Illinois Tollway Base Sheet Revisions
--

Section M	Base Sheet Drawings	
Drawing	Modification Summary	Effective: 03-01-2024
Weigh-in-Motion (ITS)-Series 1600		
M-ITS-1600	Weigh-In-Motion Cabinet and Foundation Details	
	Remove reference to Note 17 for Cisco switch and Cisco power supply	
M-ITS-1603	Weigh-In-Motion 3 Lanes

WEIGH-IN-MOTION 3 LANES

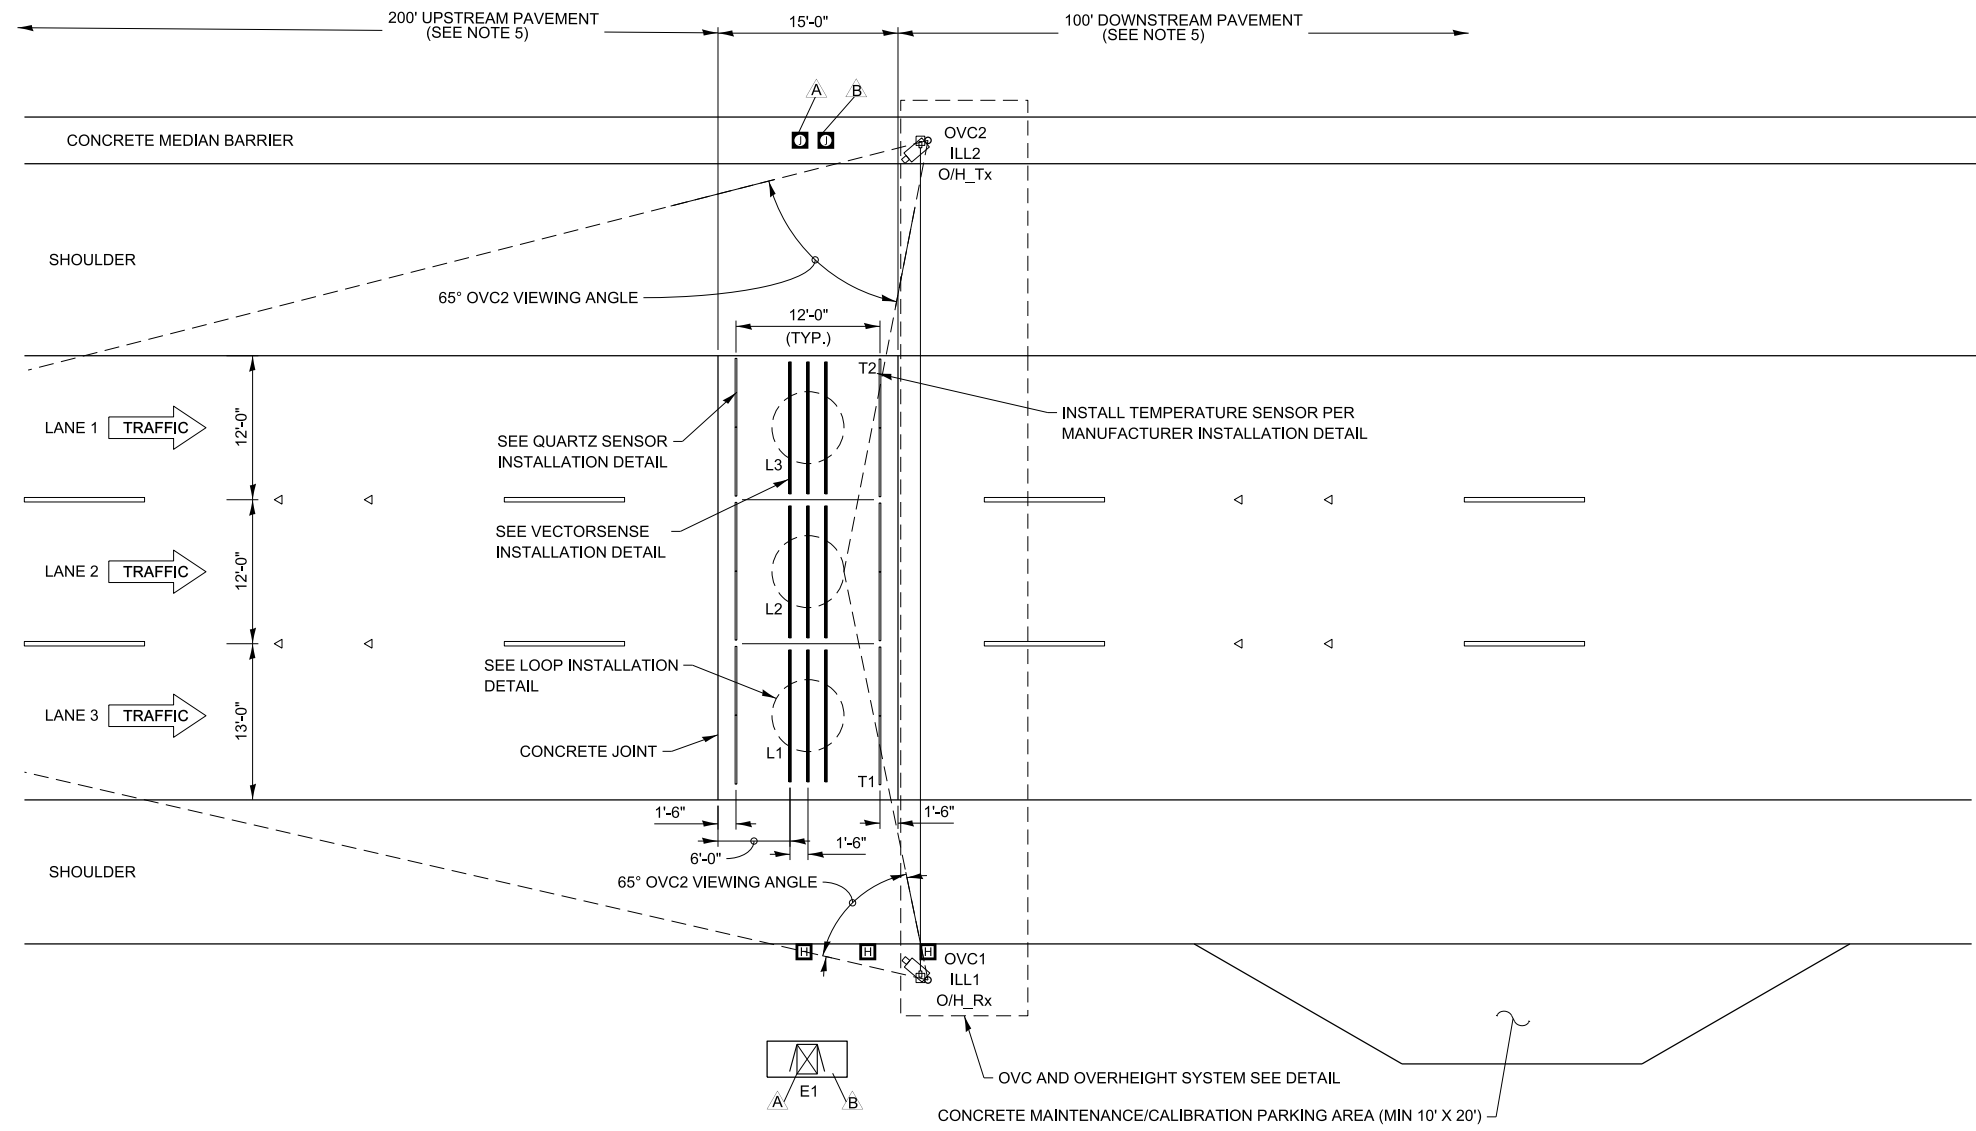
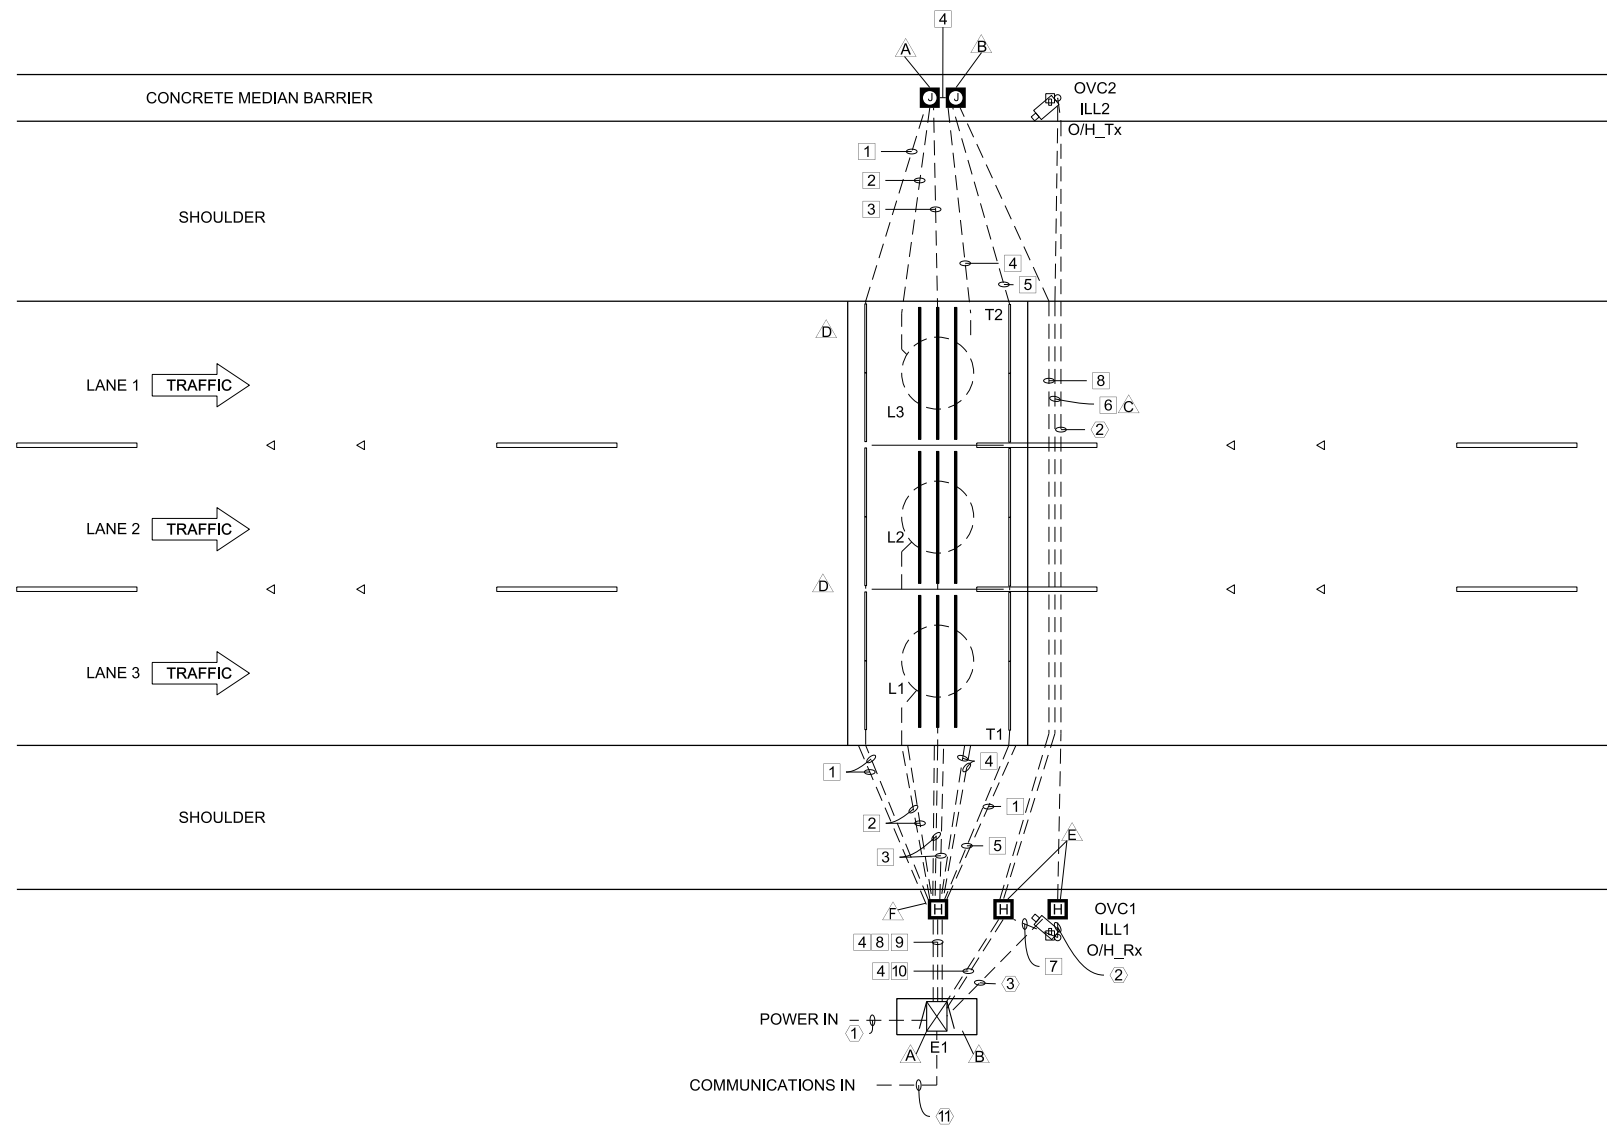
Sheet 1	Note A: Change the designation to say: Junction Box with WIM Electronics	
	Note 5: Add "straight grade obtained by diamond grinding"	
M-ITS-1604	Weigh-In-Motion 4 Lanes

- Ⓐ JUNCTION BOX WITH WIM ELECTRONICS
- Ⓜ CABINET FOUNDATION.

4. SITE CONDITIONS MUST MEET ASTM E1318-09 TYPE 1 REQUIREMENTS TO ACHIEVE OPTIMAL WIM SYSTEM PERFORMANCE.
5. A CONCRETE PAVEMENT SECTION ON STRAIGHT GRADE OBTAINED BY DIAMOND GRINDING WITH NO VERTICAL CURVES AND NO SUPERELEVATION TRANSITIONS IS REQUIRED FOR WIM LANES, FROM 200' BEFORE THE SENSORS UP TO 100' AFTER THE SENSORS, TO IMPROVE LONG TERM PERFORMANCE AND REDUCE MAINTENANCE. DIAMOND GRINDING OF THE 315' LENGTH OF CONCRETE PAVEMENT SHALL OCCUR AFTER PRECAST PANELS ARE INSTALLED.

WEIGH-IN-MOTION 4 LANES

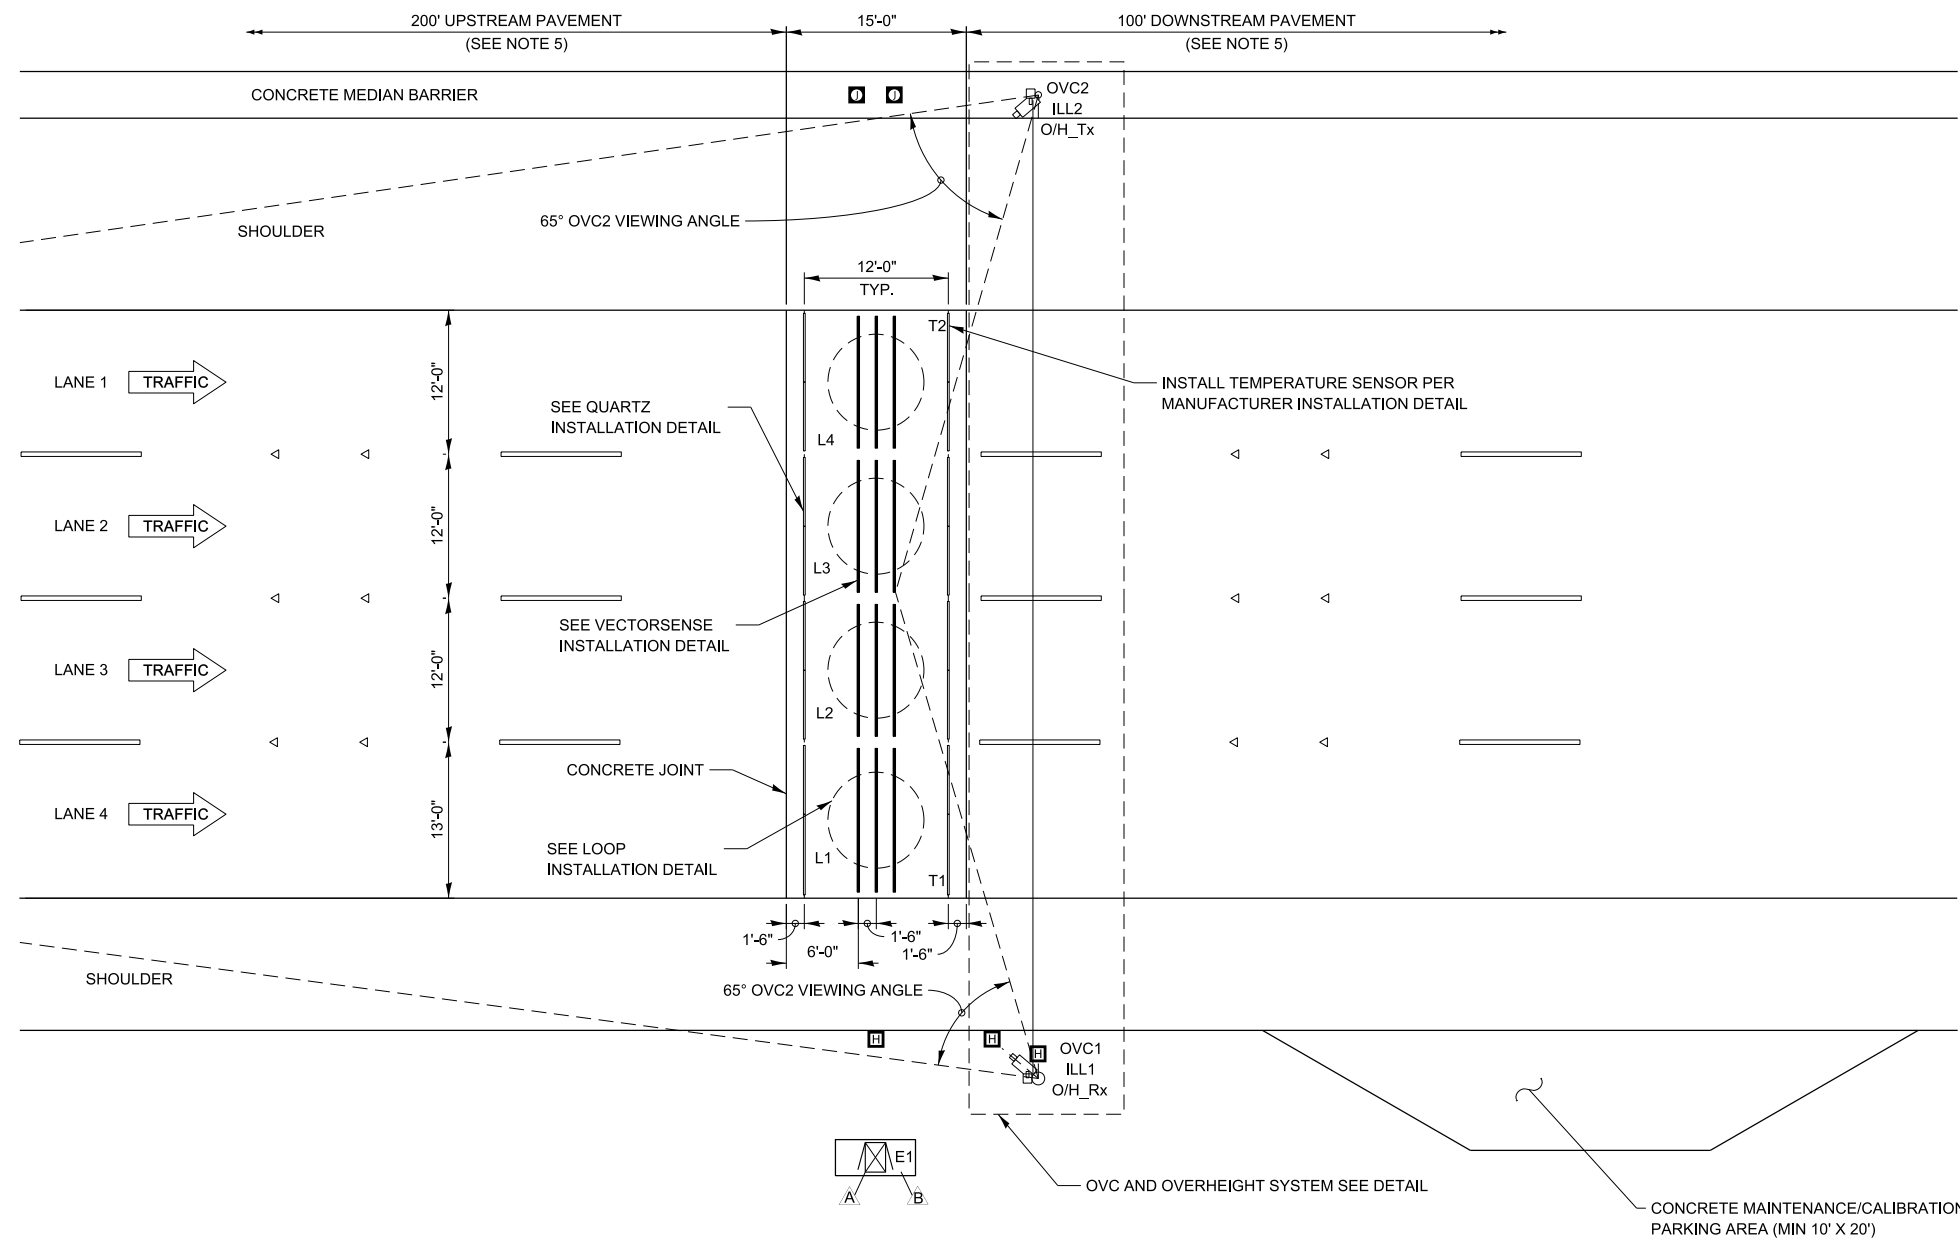
Sheet 1	Note A: Change the designation to say: Junction Box with WIM Electronics	
	Note 5: Add "straight grade obtained by diamond grinding"	
M-ITS-1605	Weigh-In-Motion 6 Lanes

- NOTES: (THIS SHEET ONLY)**
- A. JUNCTION BOX WITH WIM ELECTRONICS
 - B. CABINET FOUNDATION

4. SITE CONDITIONS MUST MEET ASTM E1318-09 TYPE 1 REQUIREMENTS TO ACHIEVE OPTIMAL WIM SYSTEM PERFORMANCE.
 5. A CONCRETE PAVEMENT SECTION ON STRAIGHT GRADE OBTAINED WITH DIAMOND GRINDING WITH NO VERTICAL CURVES AND NO SUPERELEVATION TRANSITIONS IS REQUIRED FOR WIM LANES, FROM 200' BEFORE THE SENSORS UP TO 100' AFTER THE SENSORS, TO IMPROVE LONG TERM PERFORMANCE AND REDUCE MAINTENANCE. DIAMOND GRINDING OF THE 315' LENGTH OF CONCRETE PAVEMENT SHALL OCCUR AFTER PRECAST PANELS ARE INSTALLED.

WEIGH-IN-MOTION 6 LANES

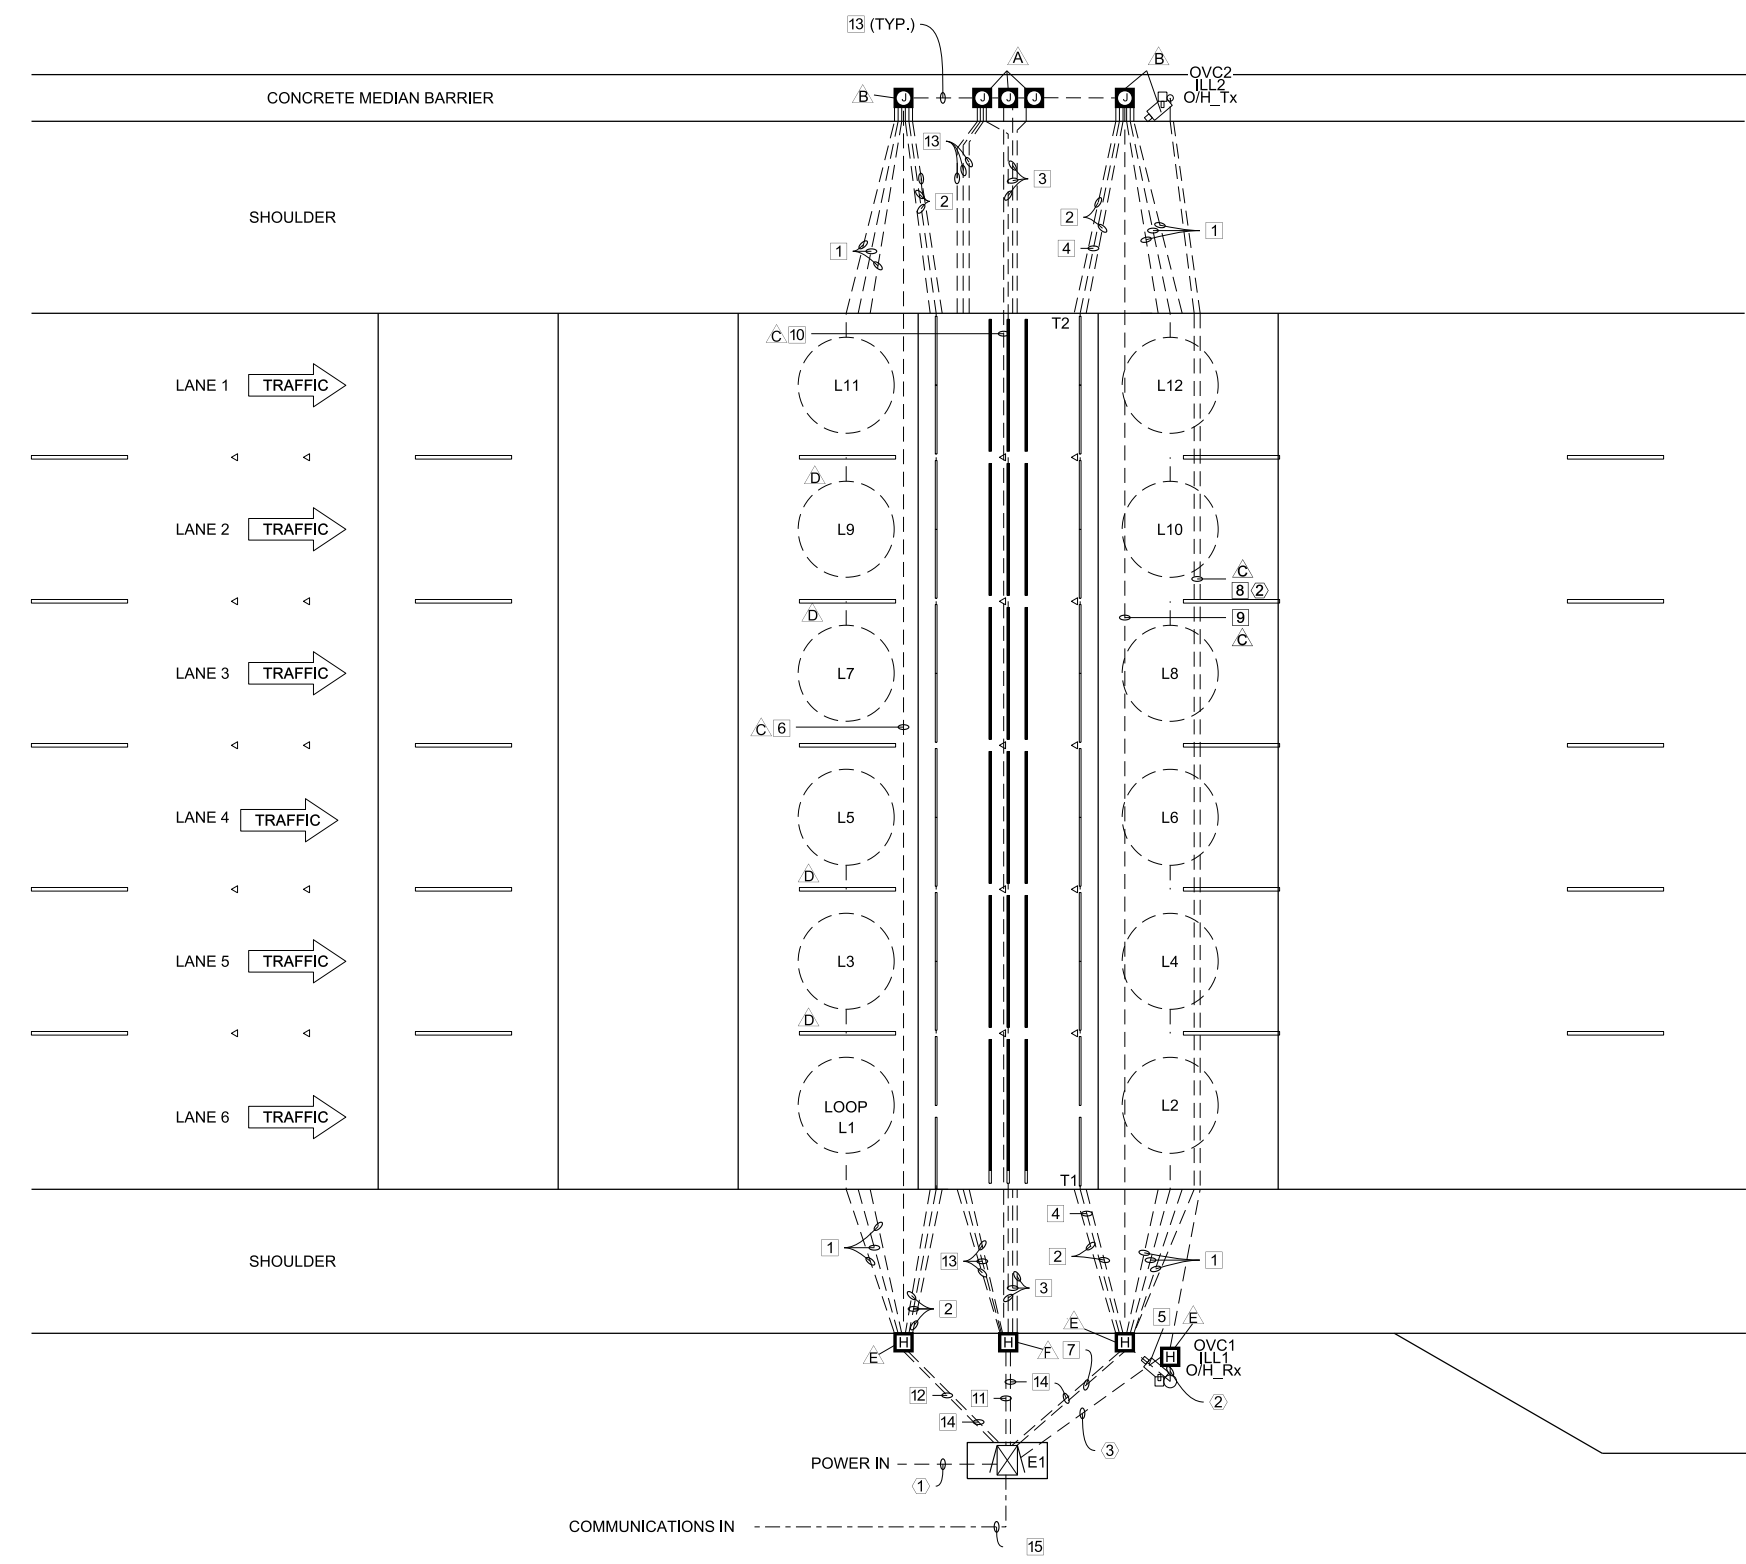
Sheet 1	Note A: Change the designation to say: Junction Box with WIM Electronics	
	Note 5: Add "straight grade obtained by diamond grinding"	
M-ITS-1606	Weigh-In-Motion Junction Box Detail	
	Plan View: added a note to say Slipformed not permitted 7 feet before the centerline of the junction box and passed 7 feet from the centerline of the junction box	
	Side View: Added detail for drain plug with a screen to prevent debris clogging the drain	
	Section B-B: Revised dimension to 8" deep	
	Section A-A: Revised dimensions of junction box to : 40"x9"x8"	
	Section A-A: Added reinforcement bars below the junction box	
	Section A-A: Added a note that the junction box shall be centered with the centerline of the median wall	
	Added Note: Slip forming the parapet or barrier is not allowed within 7-feet of the centerline of the junction box	
M-ITS-1607	Weigh-In-Motion Height Detector	
	Sensor Configuration revised to say: mounting height of each sensor at 13 feet 8 inches from the crest of the road

- NOTES:** (THIS SHEET ONLY)
- Ⓐ JUNCTION BOX WITH WIM ELECTRONICS
 - Ⓜ CABINET FOUNDATION

4. SITE CONDITIONS MUST MEET ASTM E1318-09 TYPE 1 REQUIREMENTS TO ACHIEVE OPTIMAL WIM SYSTEM PERFORMANCE.
 5. A CONCRETE PAVEMENT SECTION ON STRAIGHT GRADE OBTAINED WITH DIAMOND GRINDING WITH NO VERTICAL CURVES AND NO SUPERELEVATION TRANSITIONS IS REQUIRED FOR WIM LANES, FROM 200' BEFORE THE SENSORS UP TO 100' AFTER THE SENSORS, TO IMPROVE LONG TERM PERFORMANCE AND REDUCE MAINTENANCE. DIAMOND GRINDING OF THE 345' LENGTH OF CONCRETE PAVEMENT SHALL OCCUR BEFORE SAW CUT SLOTS ARE MADE FOR SENSOR INSTALLATION.
